ADDENDUM NO. 2

March 28, 2022

WESTCHESTER INTERMEDIATE SCHOOL ADDITIONS AND RENOVATIONS Chesterton, IN 46304

UNIT "A" MECHANICAL FIRST FLOOR VENTILATION PLAN
SCALE: 1/8" = 1'-0"

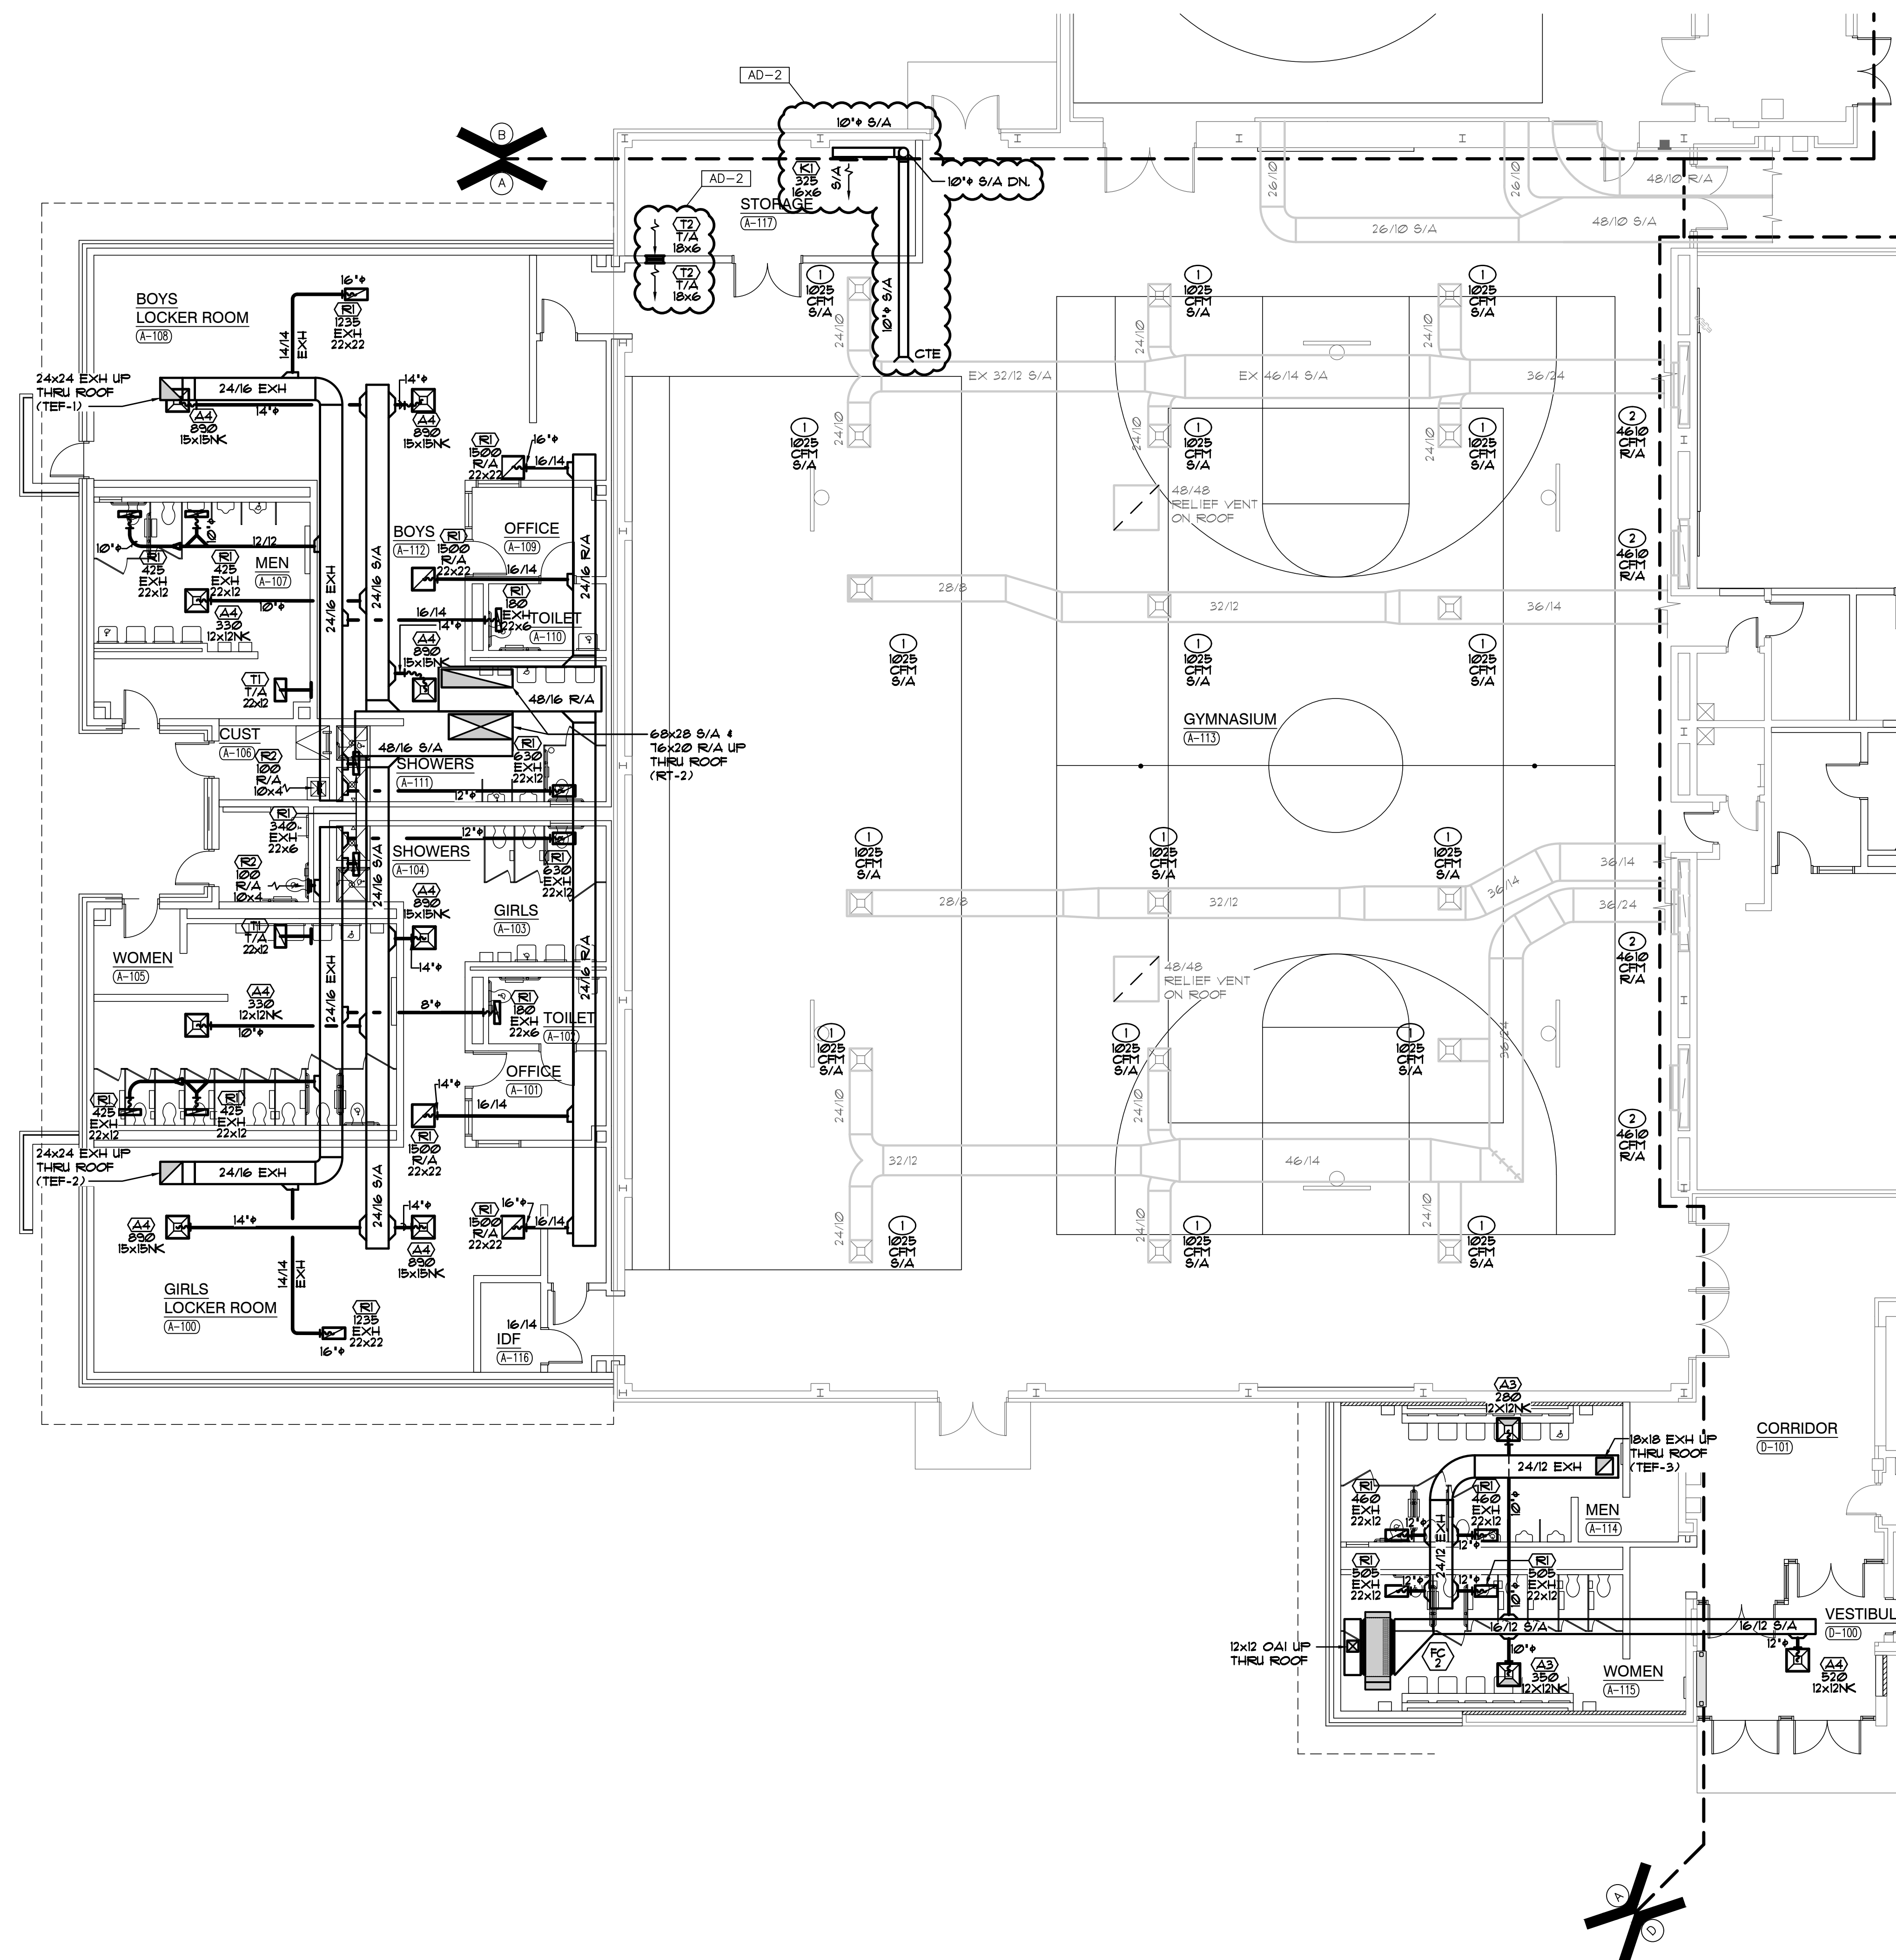
- A. Refer to revised, full-size drawing included in this Addendum, for added supply air to Storage A-117.

UNIT "D" MECHANICAL FIRST FLOOR VENTILATION PLAN
SCALE: 1/8" = 1'-0"

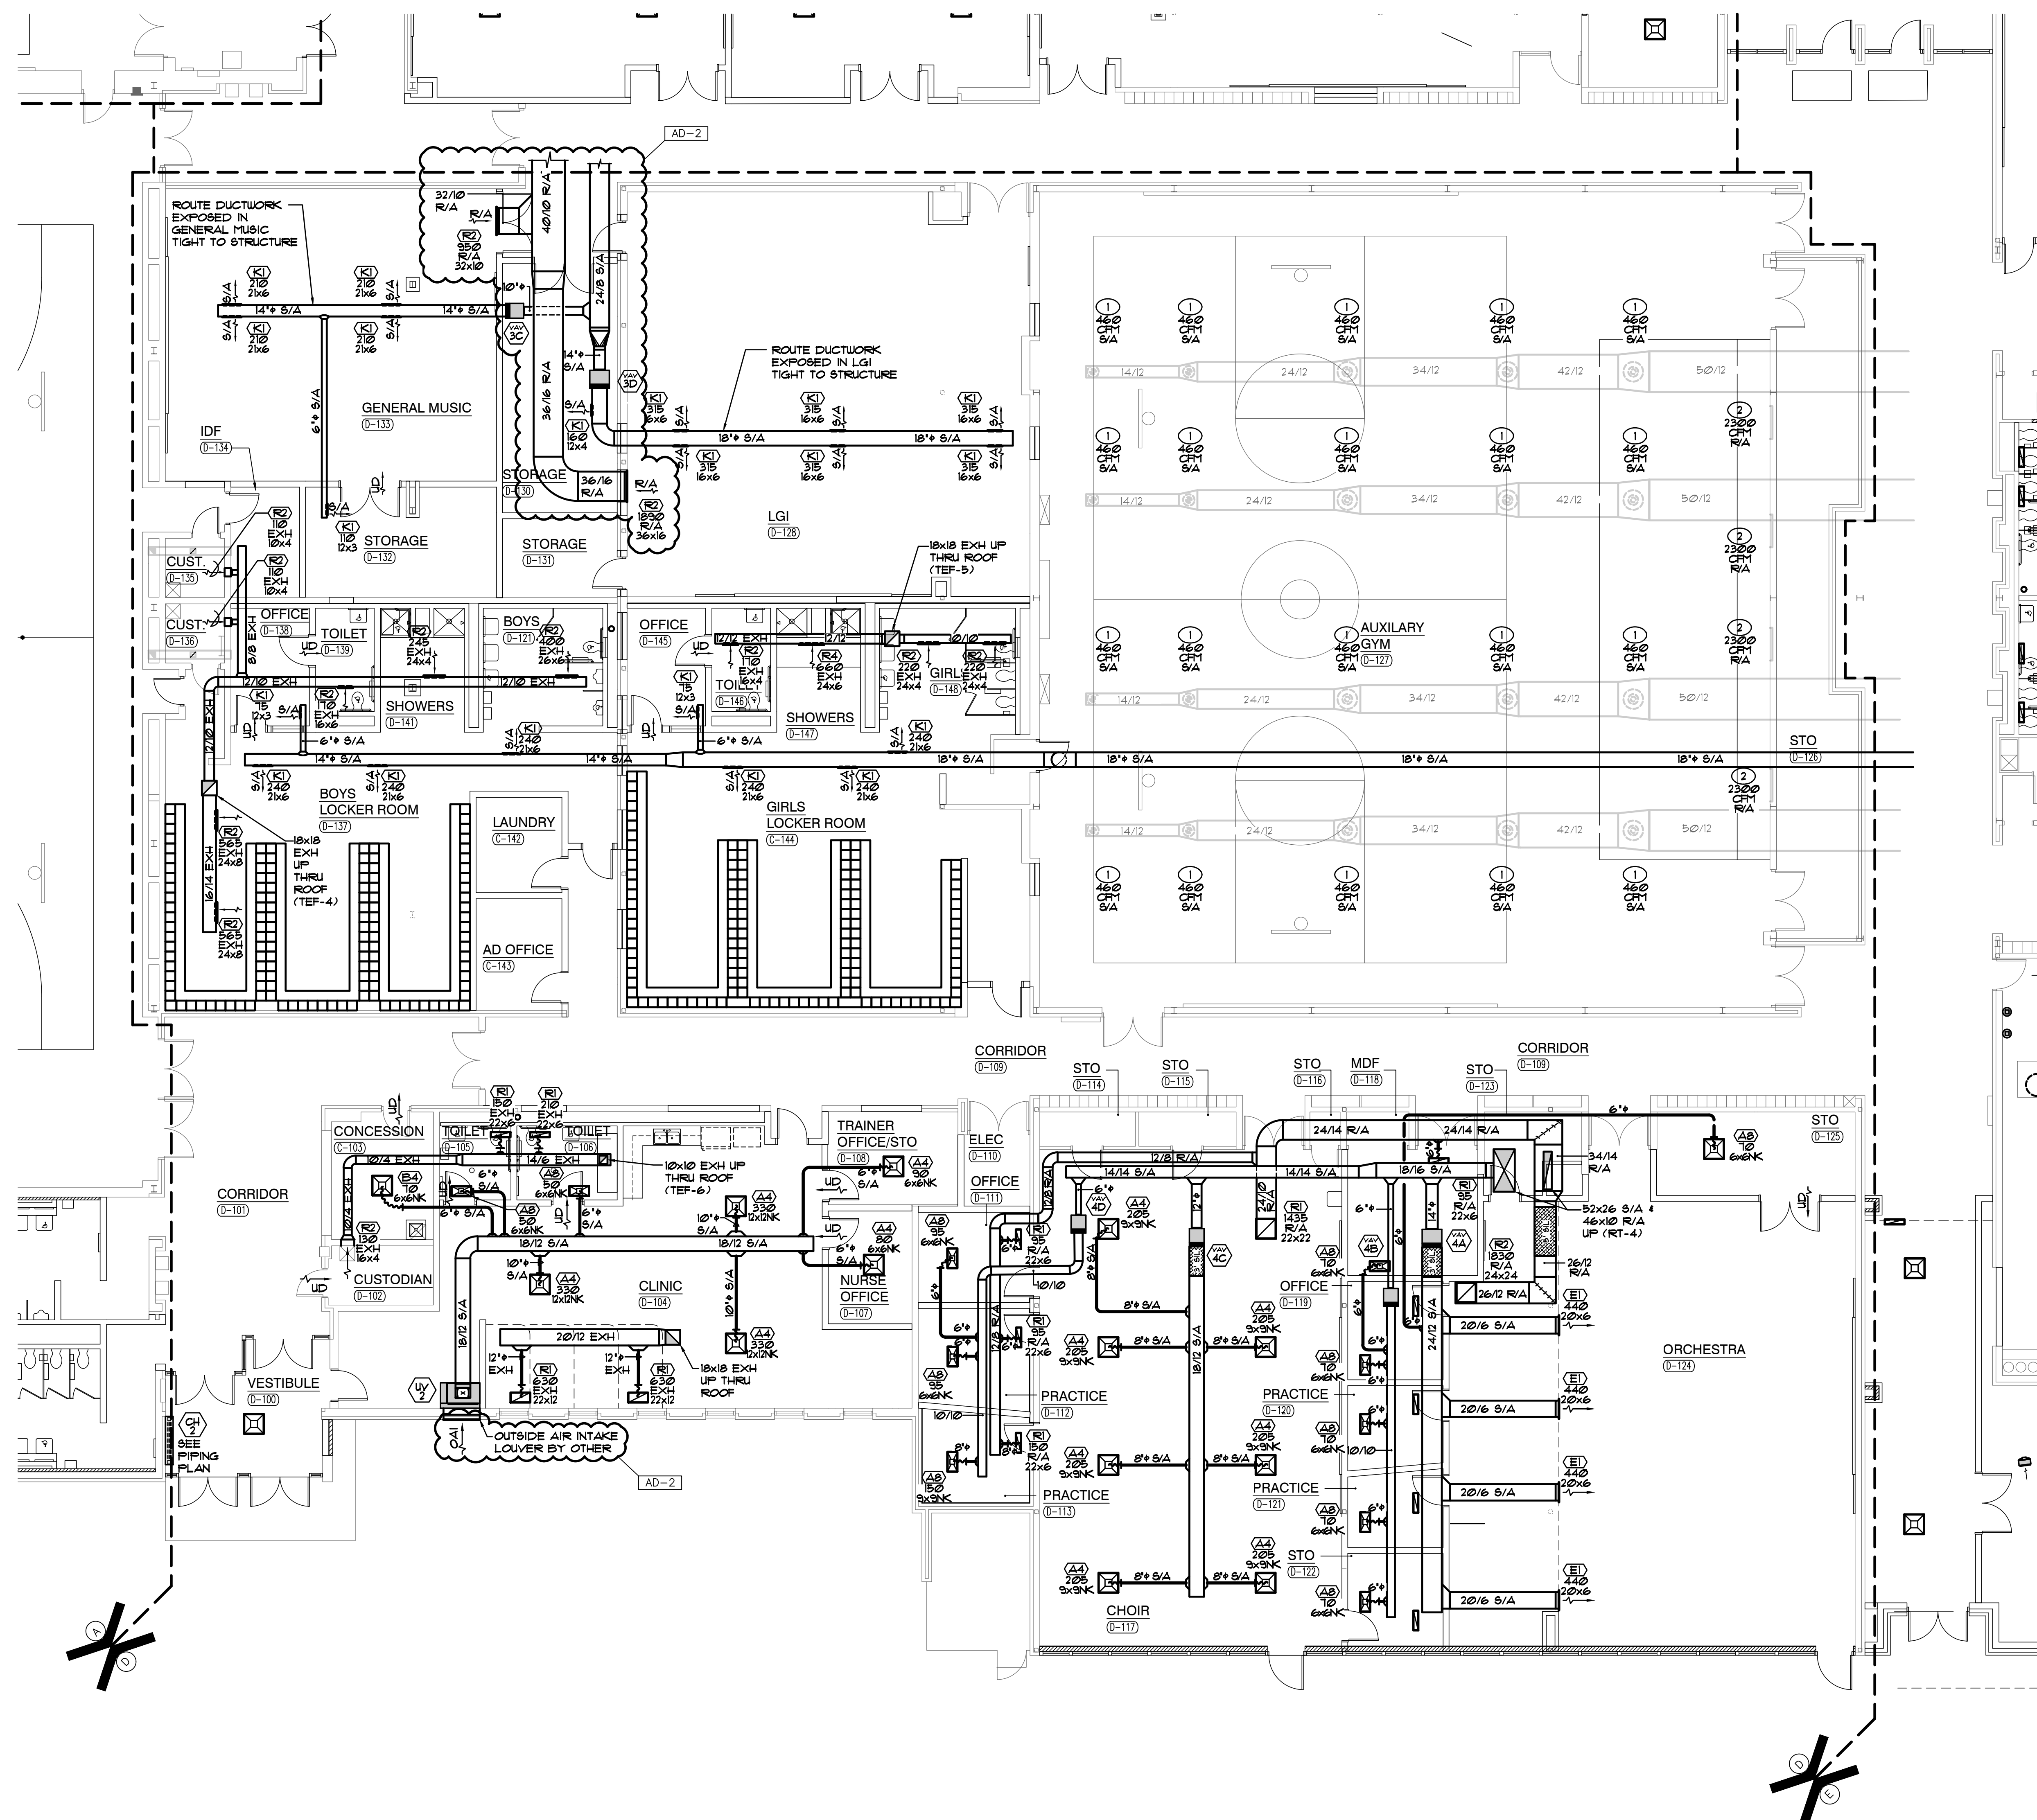
- A. Refer to revised, full-size drawing included in this Addendum, for the following revisions:
1. Revised louver note.
 2. Added return air ductwork to Music and LGI Room.

GIBRALTAR DESIGN F	SHEET MV105
------------------------------	-----------------------

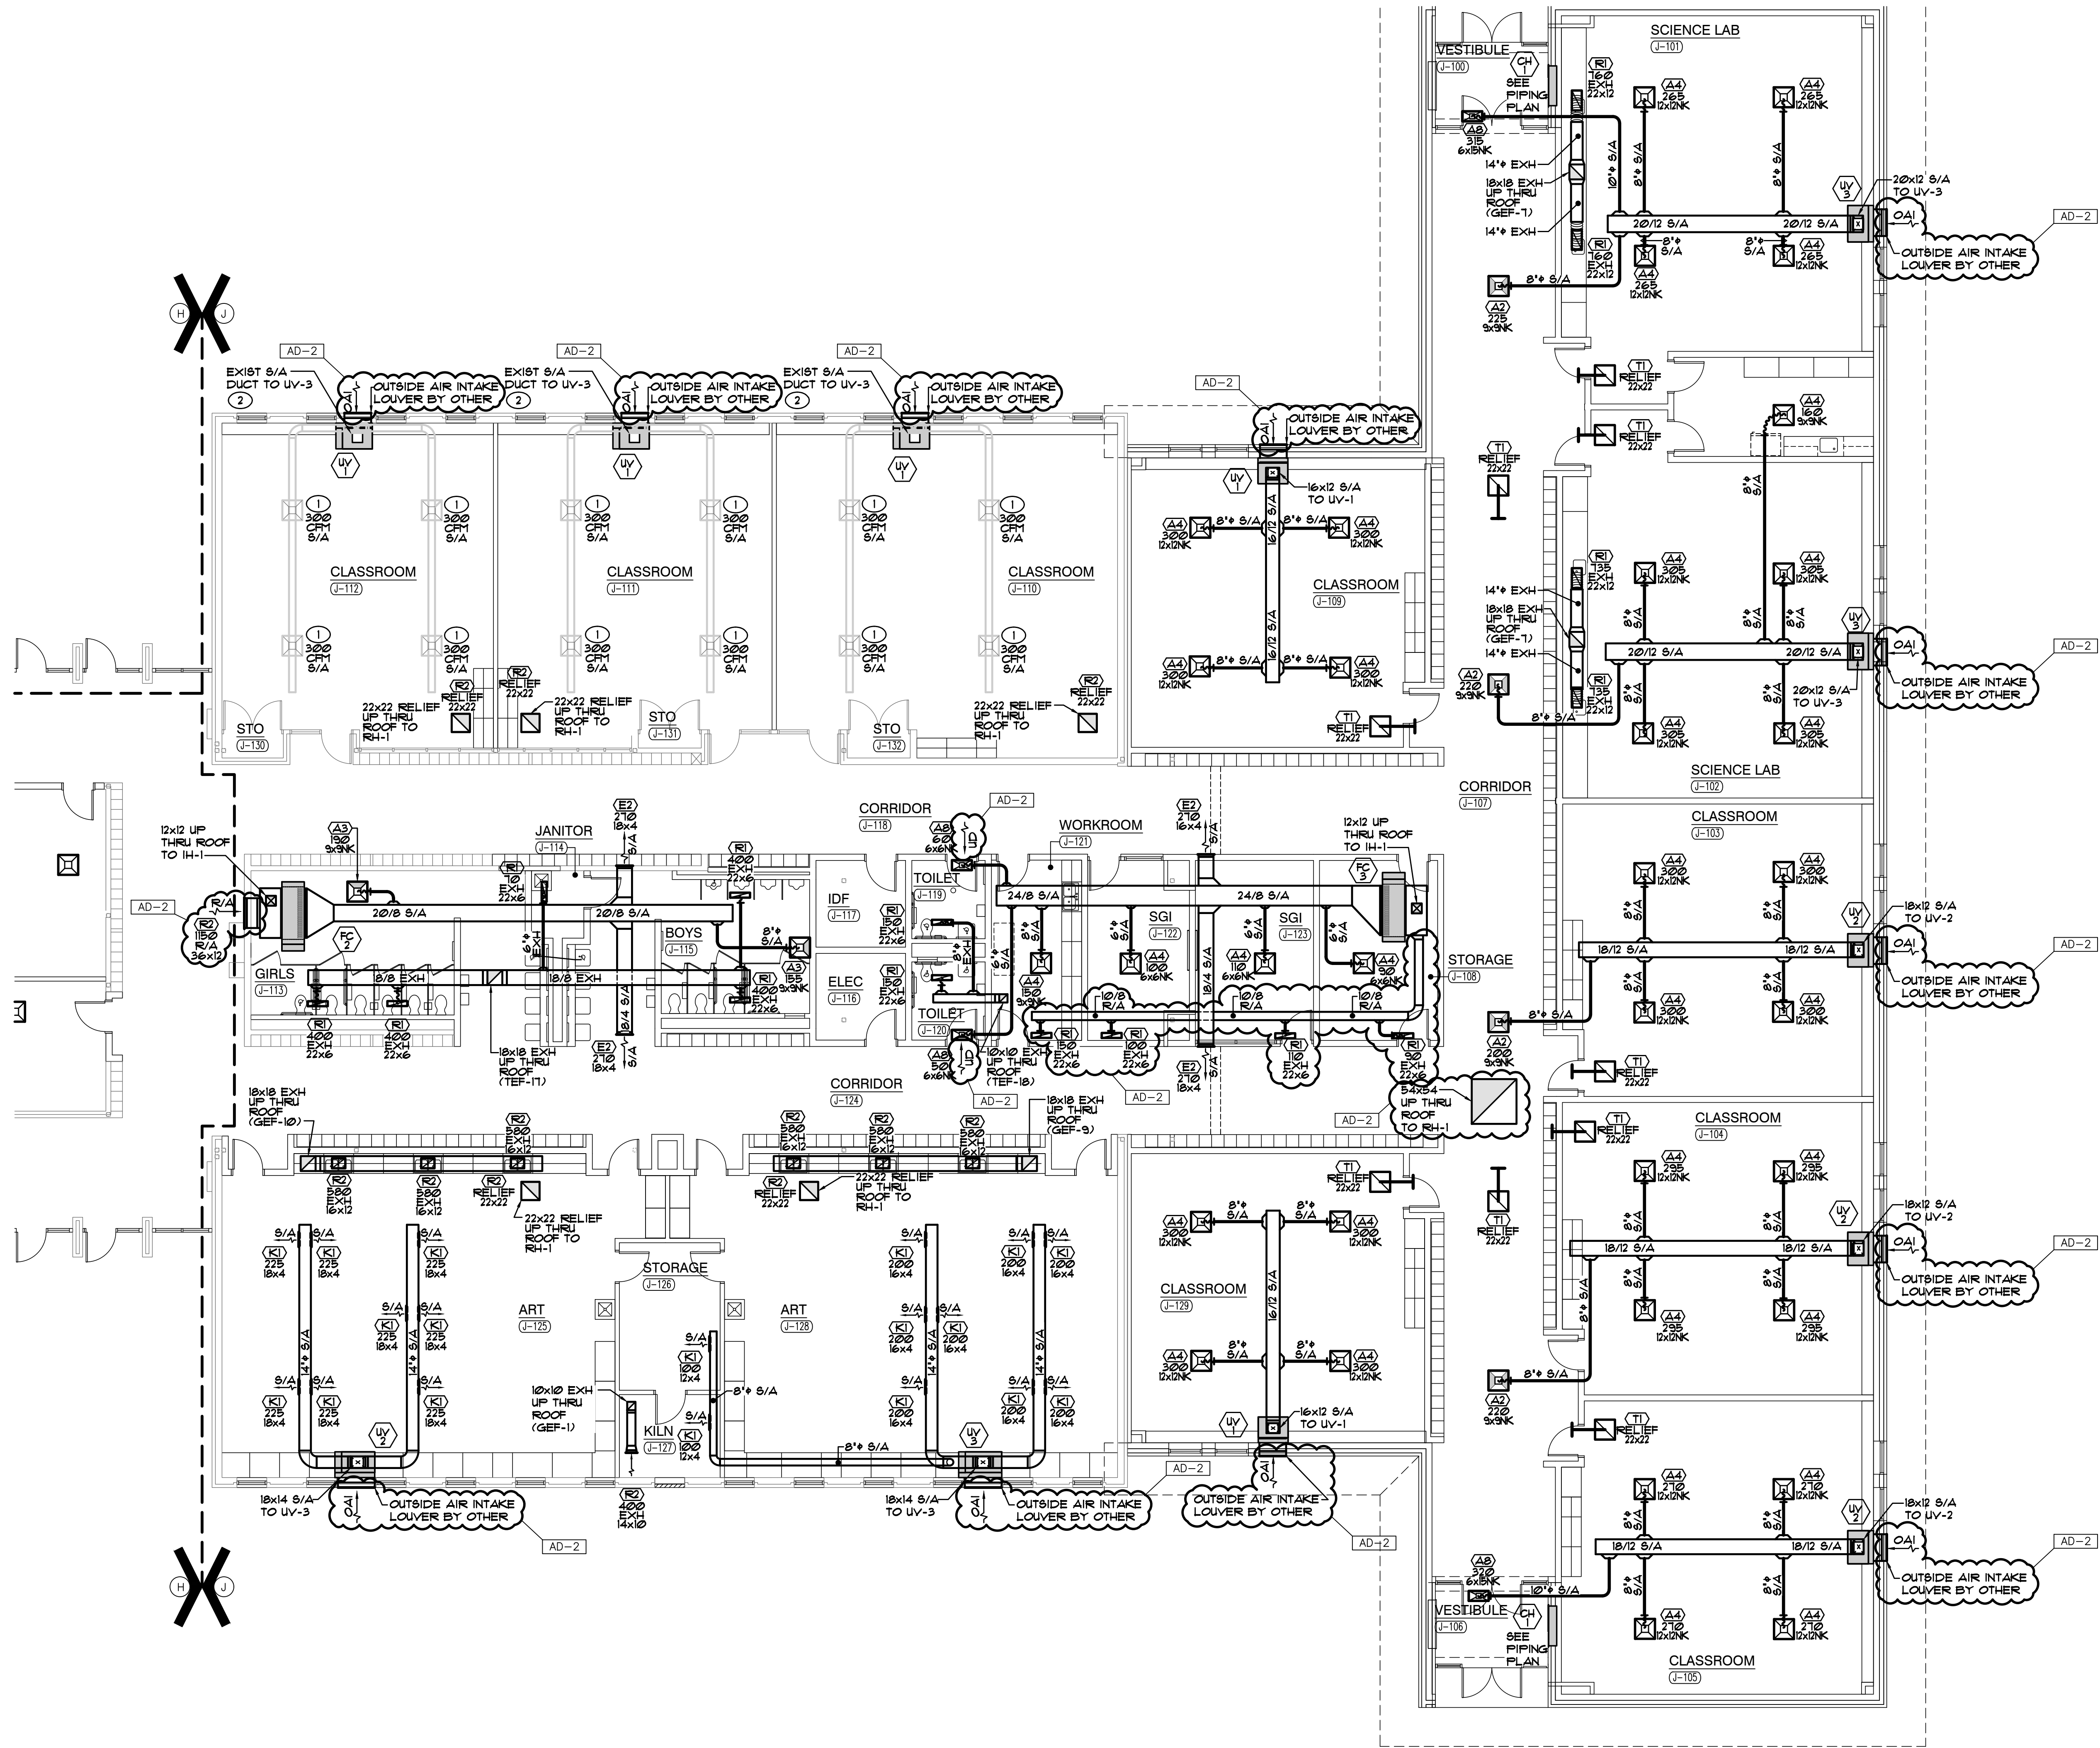
- A. Refer to revised, full-size drawing included in this Addendum, for the following revisions:
1. Added 2nd Floor Plan to sheet.
 2. Revised supply air ductwork.
 3. Added note to rebalance return air grilles.
